DRAFT Planning Commission Motion NO. M-XXXXX

Hearing Date: June 15, 2017
Case No.: **2009.0159E**
Project Address: **1500-1540 Market Street (One Oak Street)**
Zoning: C-3-G - DOWNTOWN
120-R-2 and 120/400-R-2 Height and Bulk Districts
Van Ness & Market Downtown Special Use District
Block/Lot: Block 836, Lots: 001,002, 003, 004, and 005
Project Sponsor: Steve Kuklin, Build Inc.
315 Linden Street
San Francisco, CA 94102
(415)-551-7627
Staff Contact: Diane Livia – (415) 575-8758
diane.livia@sfgov.org

DATE: June 1, 2017
TO: Members of the Planning Commission and Interested Parties
FROM: Lisa Gibson, Environmental Review Officer
Re: **Attached Responses to Comments on Draft Environmental
Impact Report Case No. 2009.0159E, 1500 Market St. (One Oak)**

CITY AND COUNTY OF SAN FRANCISCO
PLANNING DEPARTMENT: CASE NO. 2009.0159E

(NEW) FIGURE 2.17: REVISED OAK PLAZA, PLAN

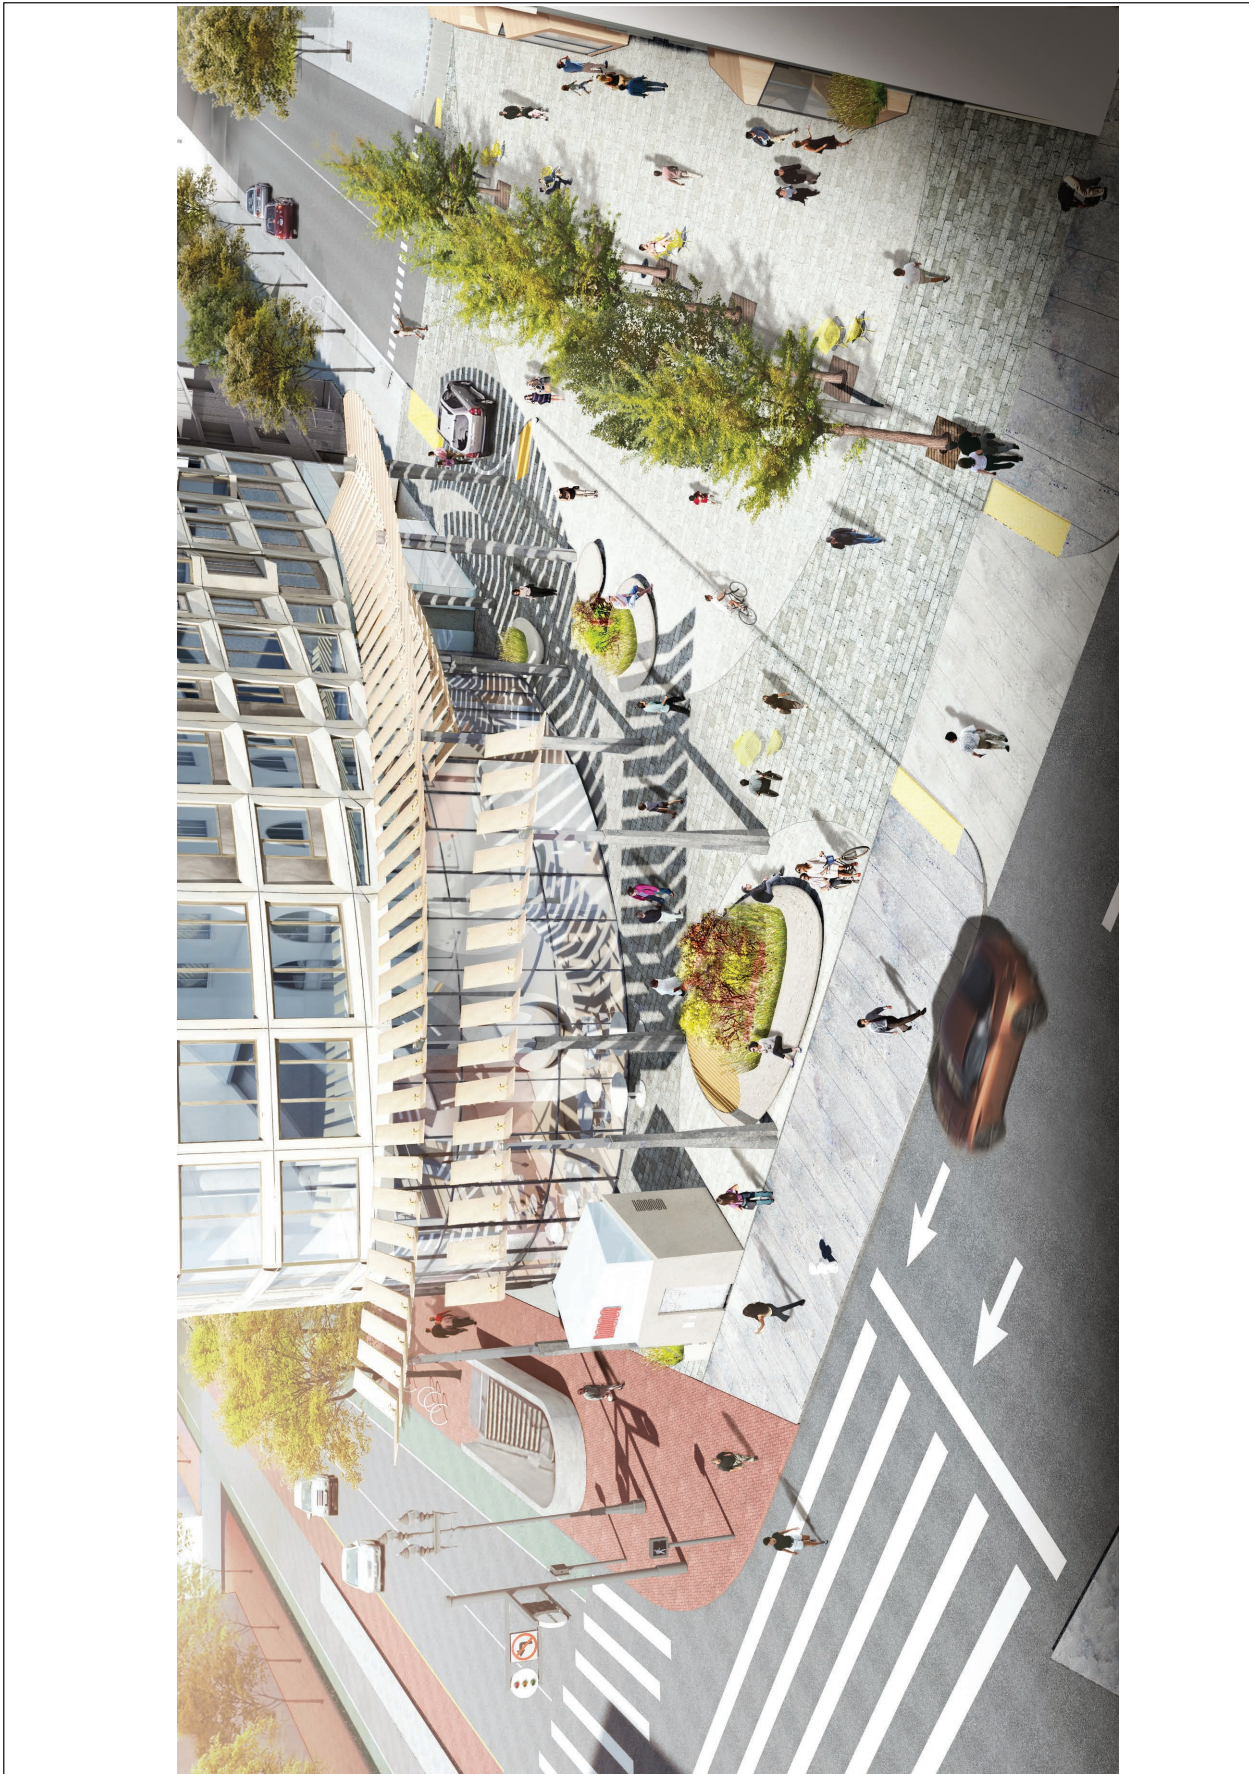
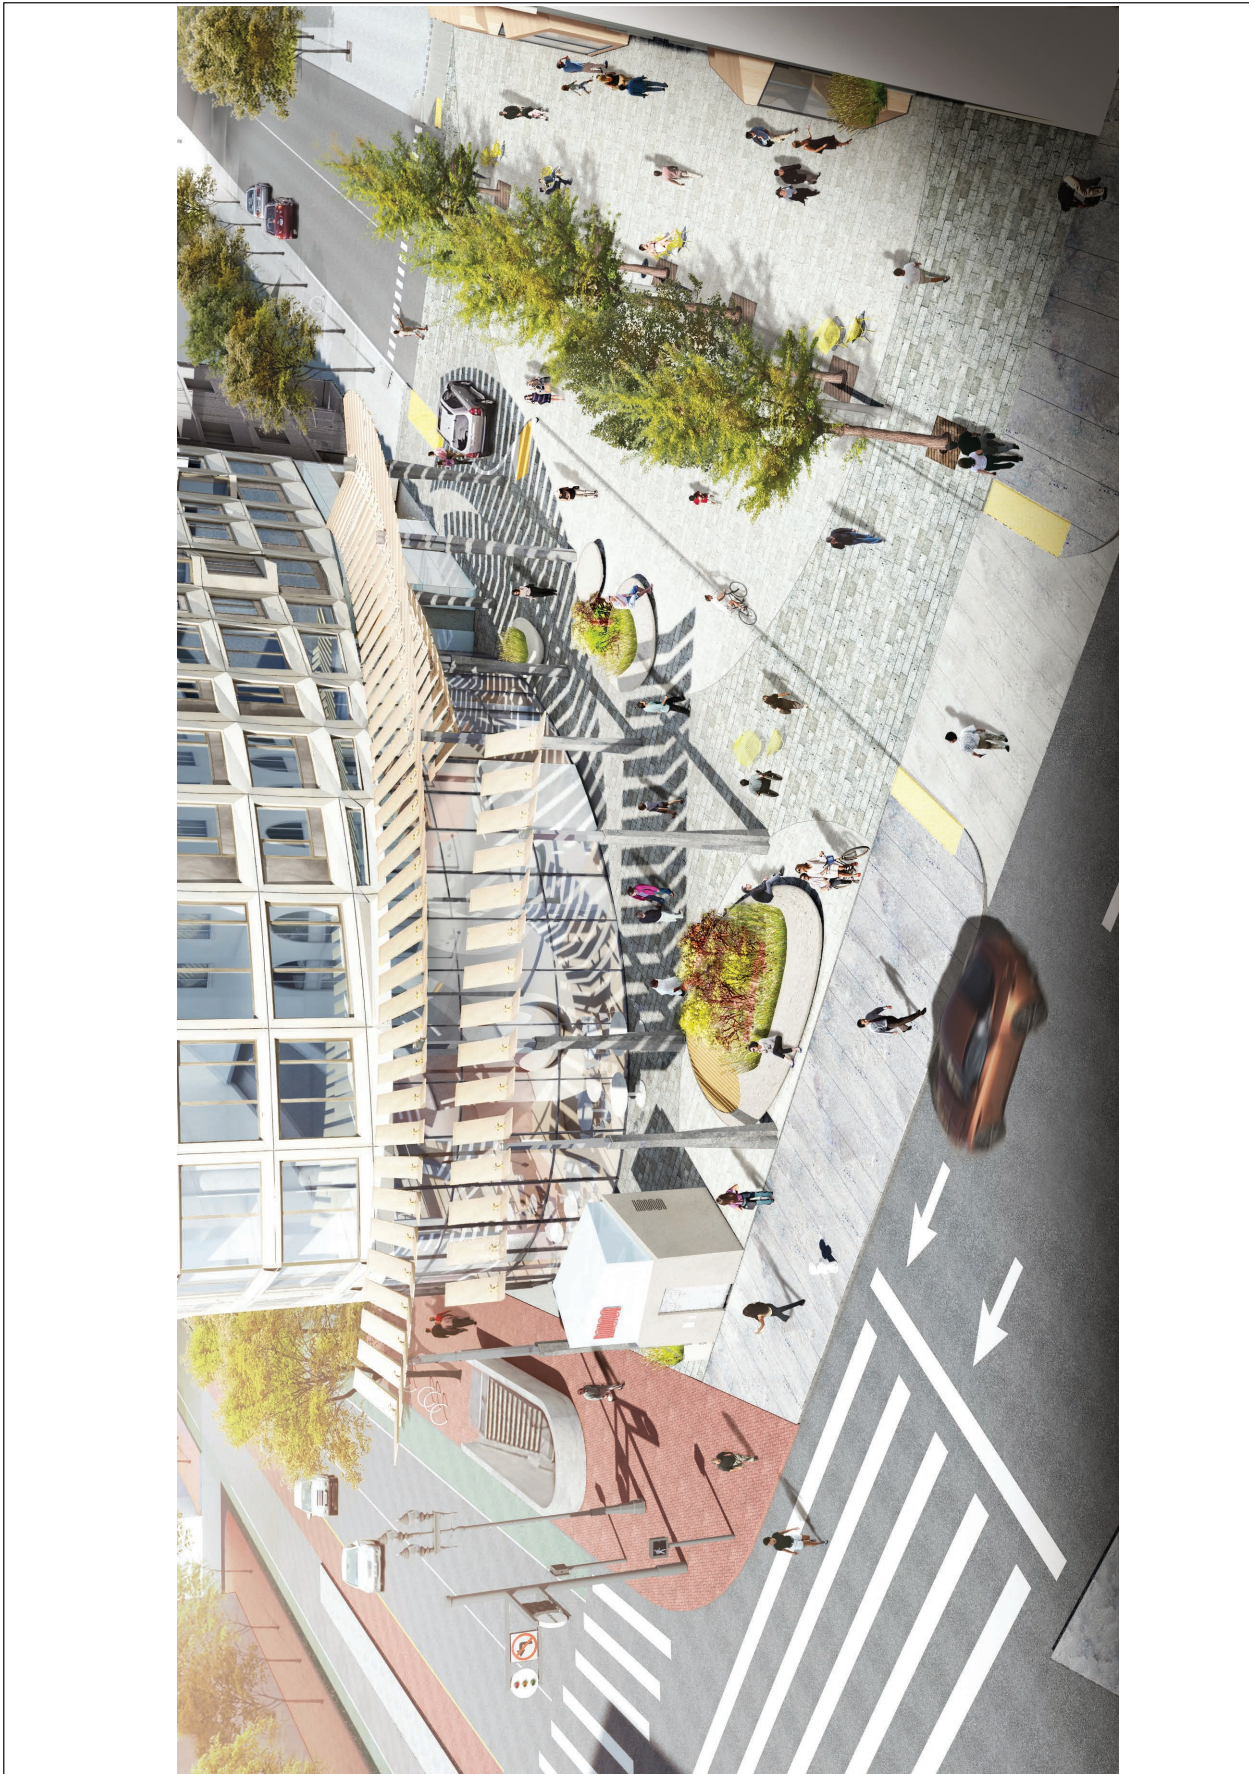
The design of the Oak Plaza wind canopies has been revised under the preferred project. See new Figure 2.17 on RTC p. 2.4. The revised canopies under the preferred project would consist of

three freestanding pergola-like structures comprised of perforated metal blades, each forming a broad, wing-like “V,” suspended along a central spine supported by vertical columns. In plan view, the blade coverage would be up to 75 percent porous, including the spaces between the blades. Two of the canopies would generally follow the curve of the tower base, while the third canopy would have an opposing converse curvature, rising in height from 18 feet above the Oak Street lobby entrance to 30 feet at the Market Street property line.

**FIGURE RTC-1: AREA PLANS AND PLANNING AREAS
NEAR THE ONE OAK PROJECT SITE**

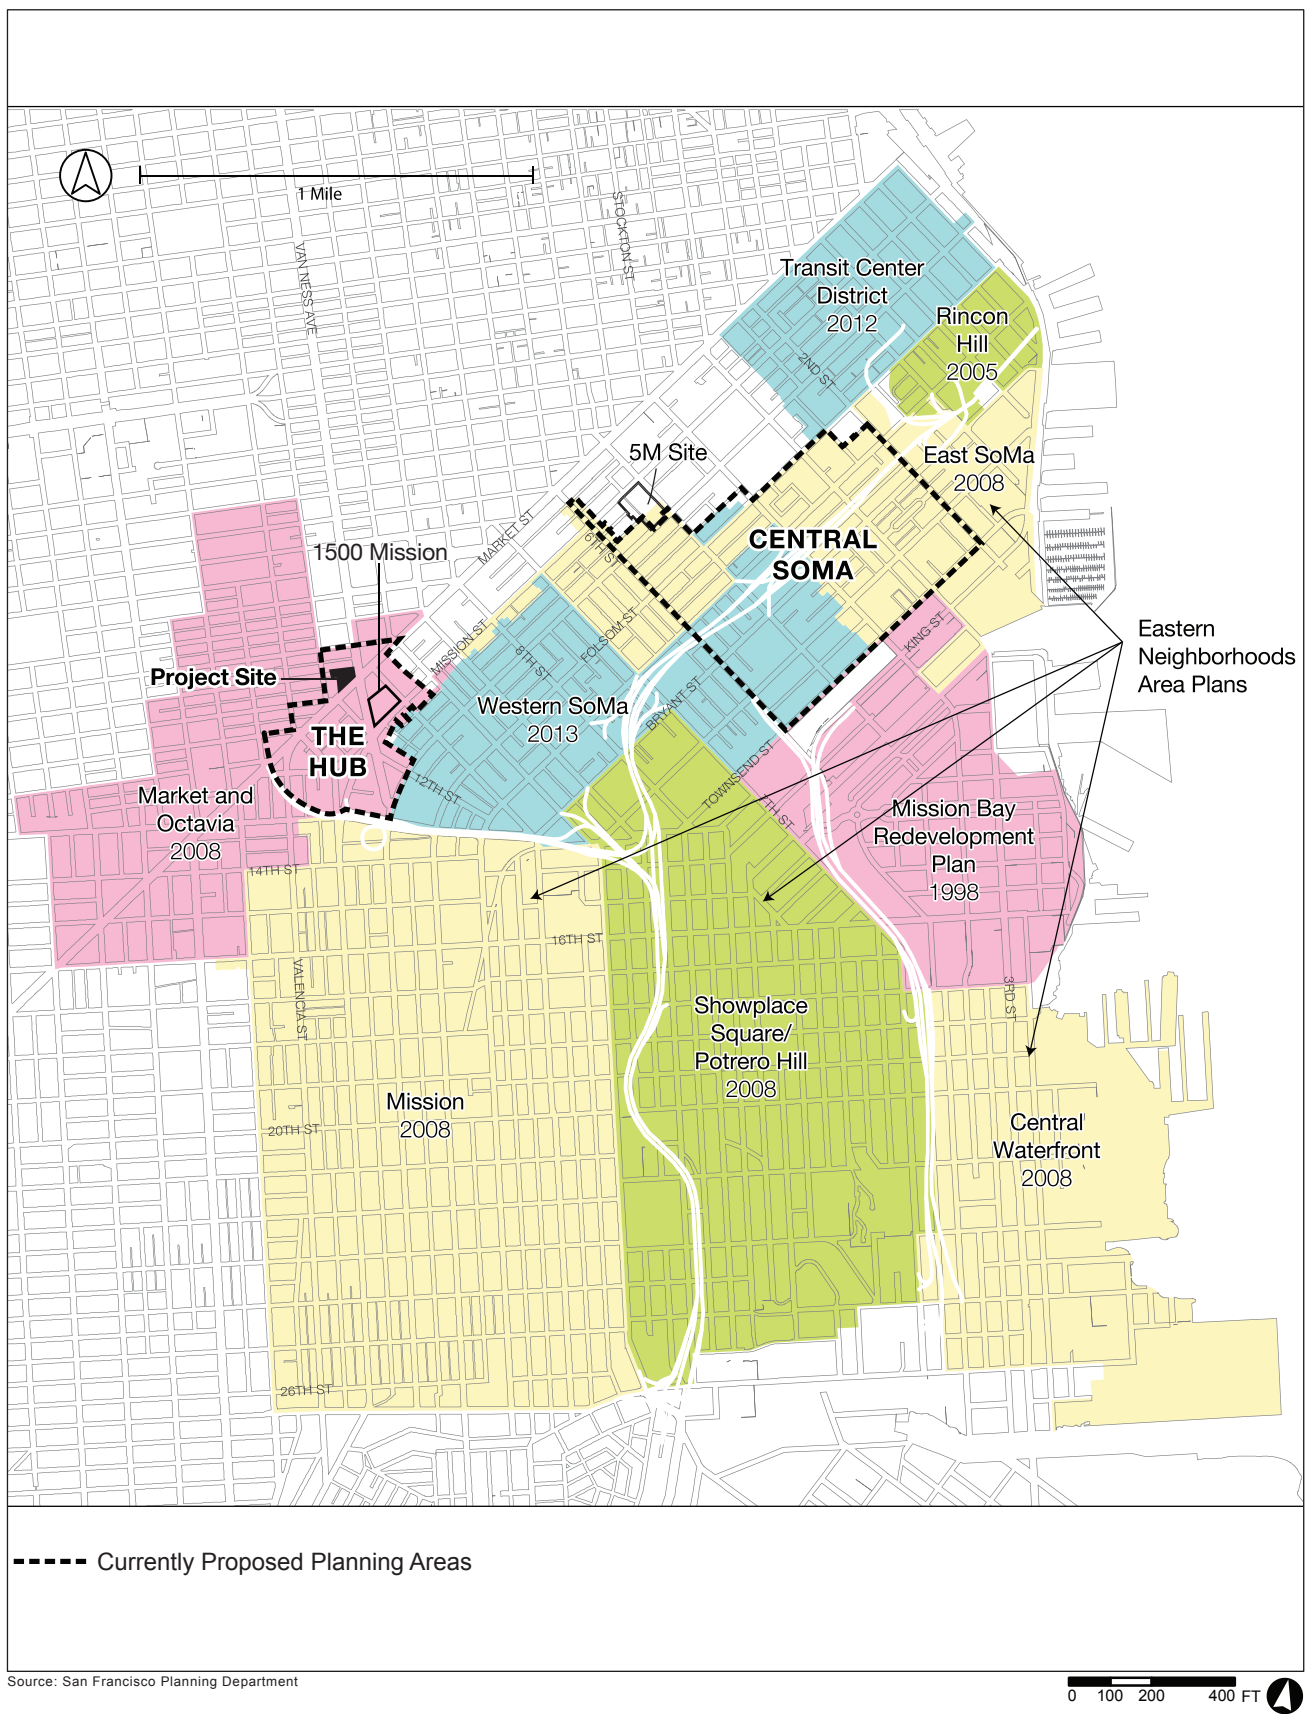
Figure RTC-1: Area Plans and Planning Areas Near the Oak Street Project Site, shows the recently adopted area plans, including the Market & Octavia Area Plan (adopted in 2008), the four Eastern Neighborhoods plans (Mission, Showplace Square/Potrero Hill, Central Waterfront, East SoMa) (adopted in 2008), the Western SoMa Plan (adopted in 2013), Rincon Hill Plan (updated plan adopted in 2005), and Transit Center District Plan (adopted in 2012). The figure also shows the area of the proposed Central SoMa Plan and the area covered by the proposed Hub planning effort. The nearby-proposed (1500 Mission Street Project, Case No. 2014-000362ENV) site is also shown, as is the approved 5M Project site. Each of these plans contains parking maximums, rather than parking minimums.

The EIR’s analysis of Land Use is adequate under CEQA because a sufficient description of existing uses was provided to establish that the addition of the proposed uses would not result in a significant land use impact applying the applicable significance thresholds. The inclusion of the requested additional details about the MO Plan, the *Western SOMA Plan*, the Van Ness and Market Downtown Residential Special Use District, the proposed *Central SoMa Area Plan*, required residential parking in the area, and the proposed Hub Project is not necessary for an

FIGURE RTC-2: REGIONAL FREEWAY FACILITIES

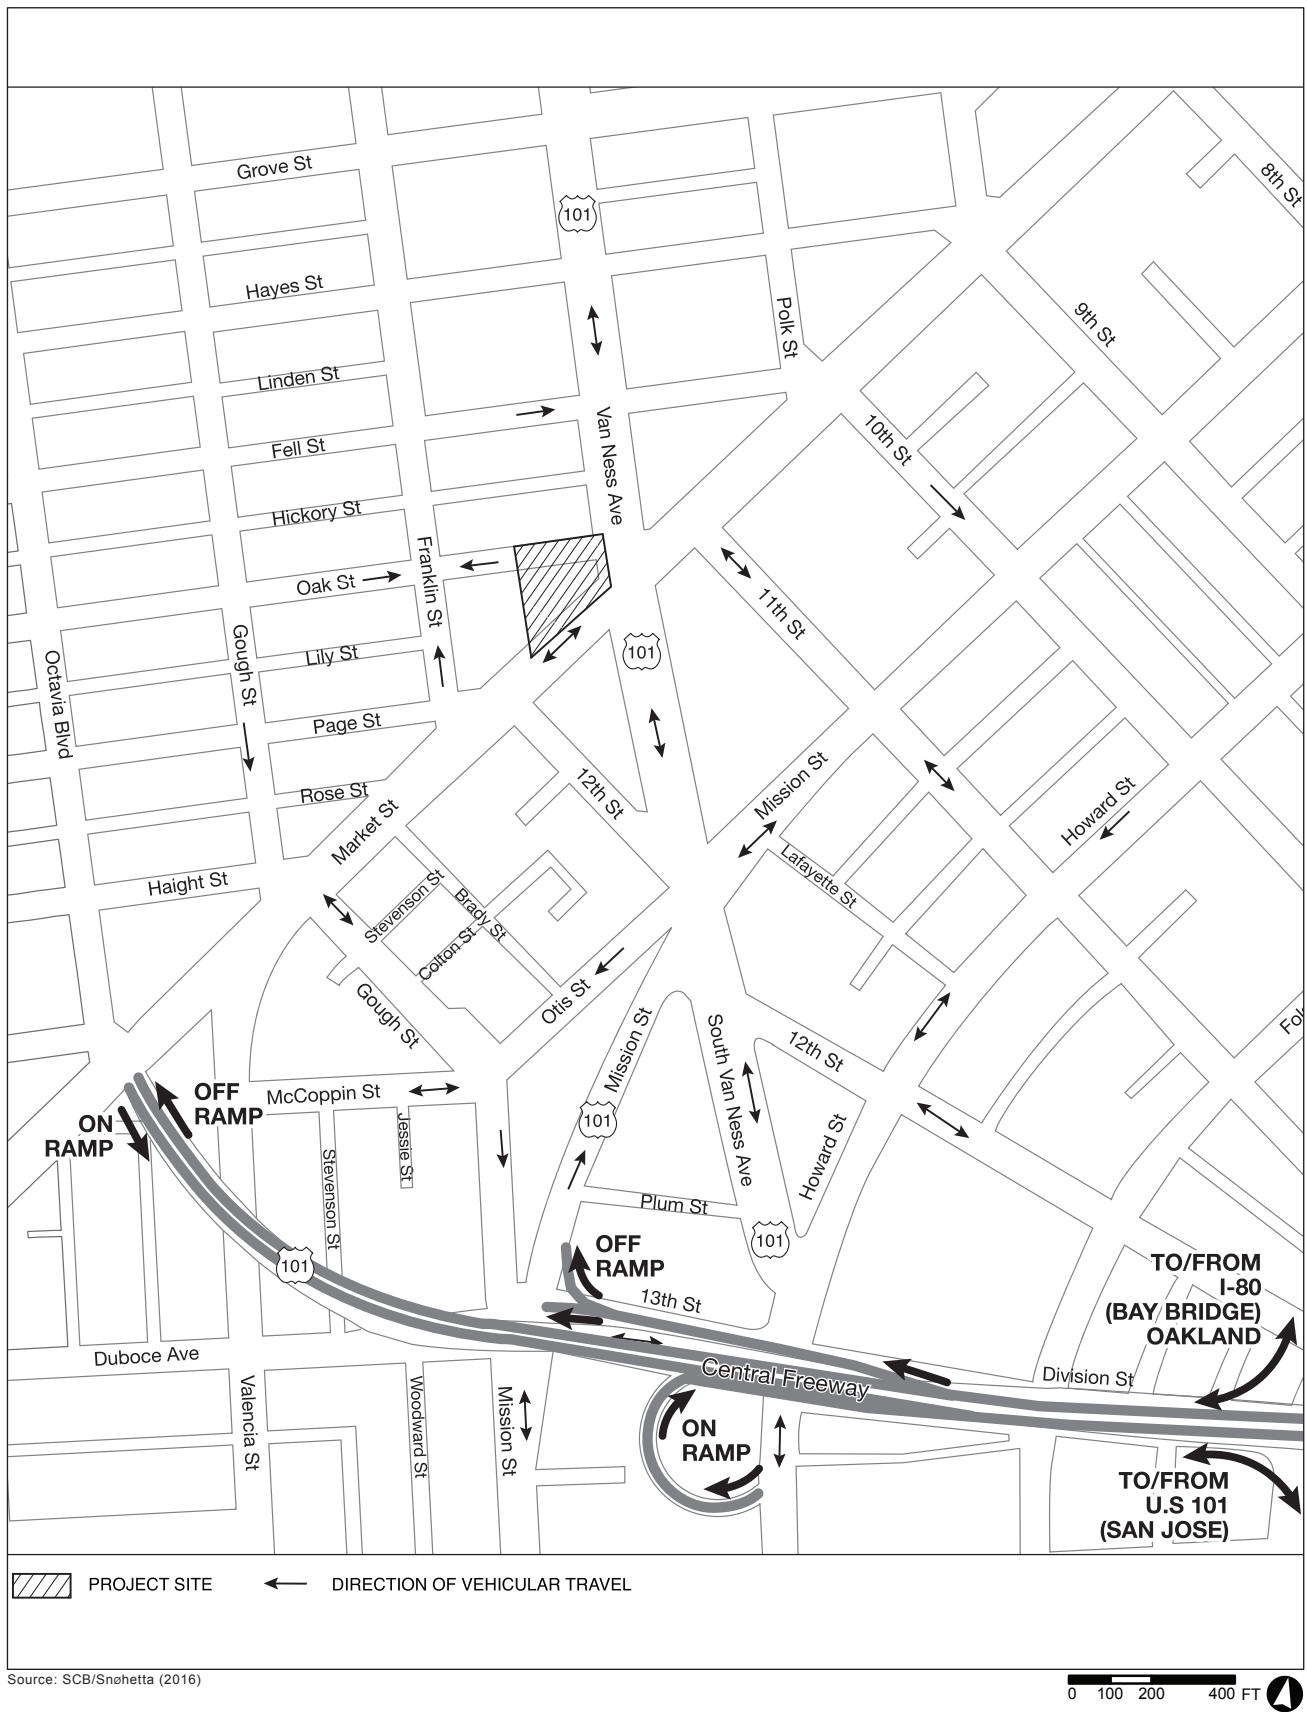
“A MAP of the freeway access and ramps will help understand travel patterns and possible impacts. And direct attention to the excessive parking provided in this "TRANSIT RICH" area. There is a freeway off ramp AT THE CORNER to the right of the Planning Department. There is an on ramp at South Van Ness and 13th. There is a Central Freeway ramp BEHIND the Planning Department. (*Sue C. Hestor, Letter, January 10, 2017 [I-Hestor2-4]*)

The comment requests a map presenting the nearby freeways access ramps. **Figure RTC-2: Regional Freeway Facilities**, presented on the next page, identifies the regional freeway connections in the vicinity of the project site. The project site is about 1,600 feet east of the U.S. 101 ramps at Octavia Boulevard, 1,900 feet north of the U.S. 101 off-ramp at Mission Street, and 2,200 feet north of the U.S. 101 on-ramp at South Van Ness Avenue. Access between the project site and the freeway facilities is described on EIR pp. 4.C.1-4.C.2, and therefore the EIR text does not need to be amended to state that the freeway ramps are used to enter and exit San Francisco.
